Work Order ID 96776

Item Name: Crosstube Turning Detail

<b>DART AEROSPACE LTD</b>	<b>Work Order:</b>	96776
<b>Description:</b> Crosstube Assembly (412 High Aft)	<b>Part Number:</b>	D412-664-243
<b>Inspection Dwg:</b> D412-664-243 <b>Rev:</b> E		<b>Page 1 of 2</b>

DRAWING NO. D412-664-243	TITLE CROSSTUBE ASSEMBLY (412 HI AFT)	REV. E	DART AEROSPACE LTD ENGINEERING ORDER		D.E.O. NO. D412-664-243-E-1	SHEET NO. SHEET 1 OF 2	SCALE NTS
DRAWN	CHECKED	MFG. APPR.	APPROVED		DE APPR.		
DATE 11.03.31	DATE 11/03/31	DATE 11.03.31	DATE 11/03/31		DATE 11-03-31

**D412-664-243  
ASSEMBLY DETAIL**

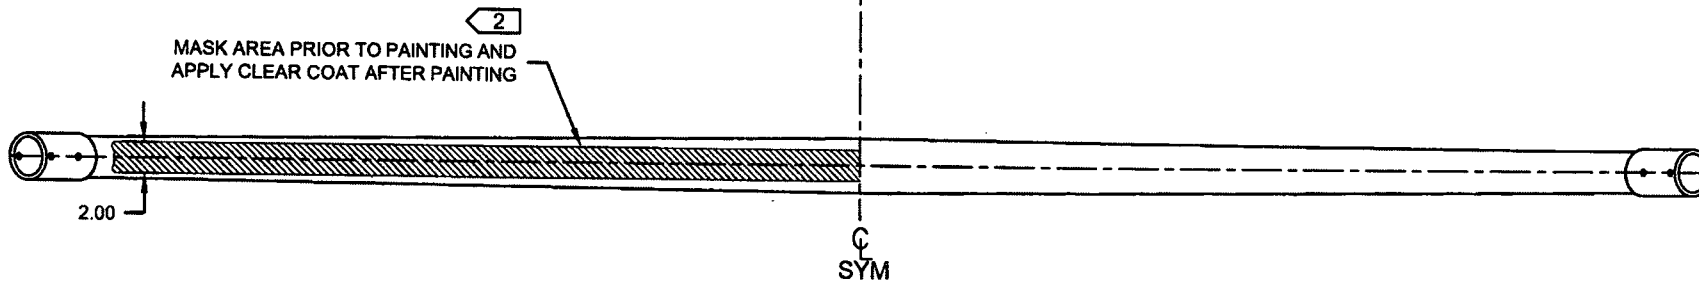
REMOVED ABRASION STRIP IN FAVOR OF A THIN LAYER OF PROSEAL 890.

D2856-600-1009 ABRASION STRIP  
D3189-1 CHAFING SHIELD (1, INSTALLED OVER ABRASION STRIP)  
MS21920-28 CLAMP, 2X  
2 PL

D3189-1 CHAFING SHIELD (1, INSTALLED OVER PROSEAL 890)  
MS21920-28 CLAMP, 2X  
2 PL

**D412-664-243  
ASSEMBLY DETAIL**

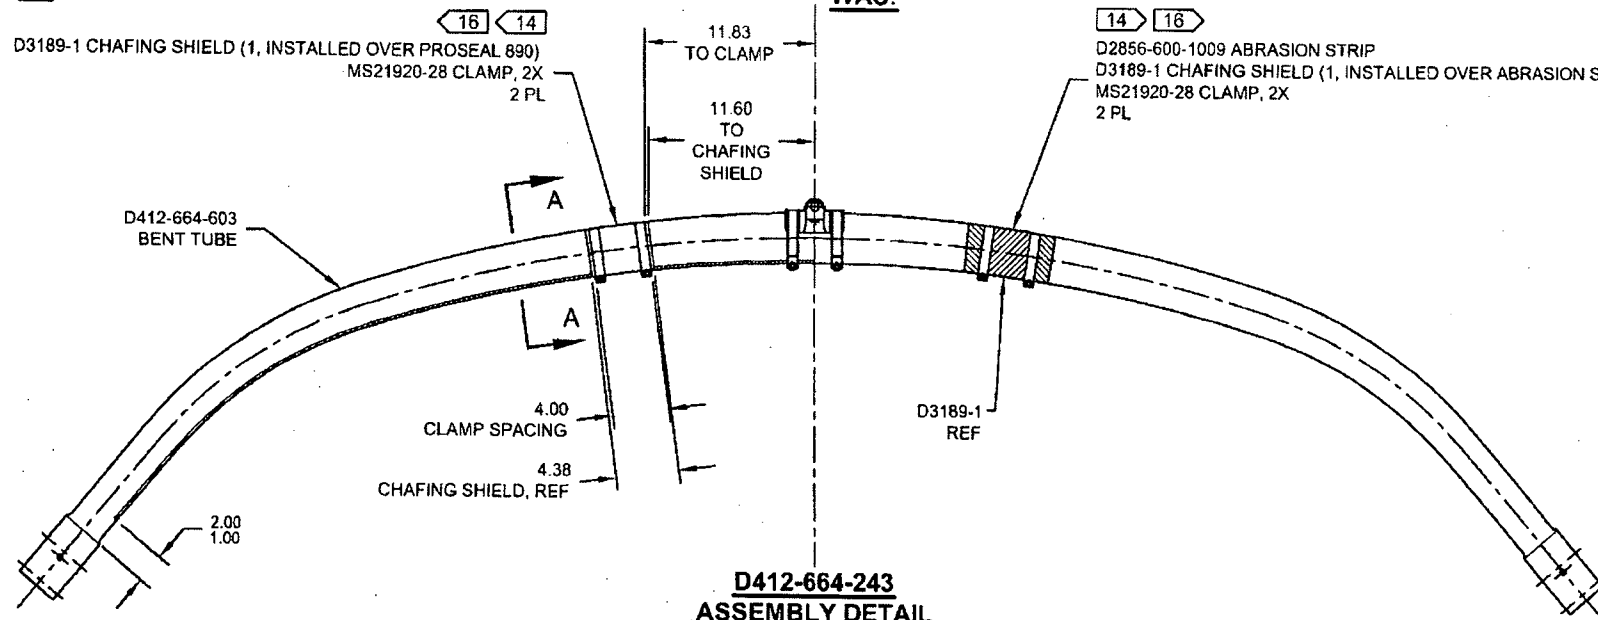
REMOVED ABRASION STRIP IN FAVOR OF A THIN LAYER OF PROSEAL 890. UPDATE INSTALLATION OF CHAFING SHIELDS AND REDUCE TORQUE TO 40-50 IN-LBS. THIS ENGINEERING ORDER SUPERCEDES DEO D412-664-243-E-1.

D2856-600-1009 ABRASION STRIP  
D3189-1 CHAFING SHIELD (1, INSTALLED OVER ABRASION STRIP)  
MS21920-28 CLAMP, 2X  
2 PL

D3189-1 CHAFING SHIELD (1, INSTALLED OVER PROSEAL 890)  
MS21920-28 CLAMP, 2X  
2 PL
